TUSCALOOSA VA QUESTIONS

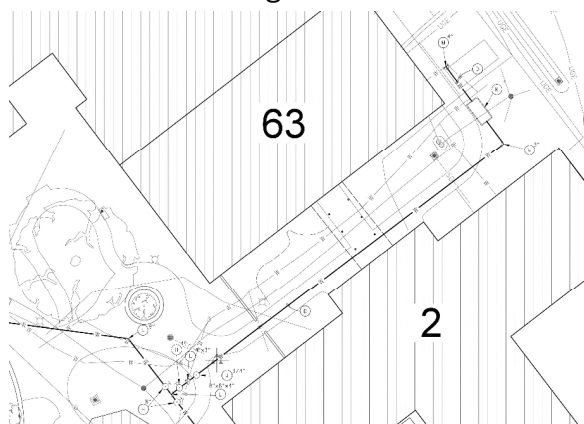
- b. For example, Building 63 service line, shown below (Dwg C-205)
 - i. 4" branch reduces to a 3/4" Meter, then increases to a 3" PE service, then reduces to a 1" Backflow, then increases to a 3" PE service, then ties into the existing 4" service. **This meter and BFP size are correct.**
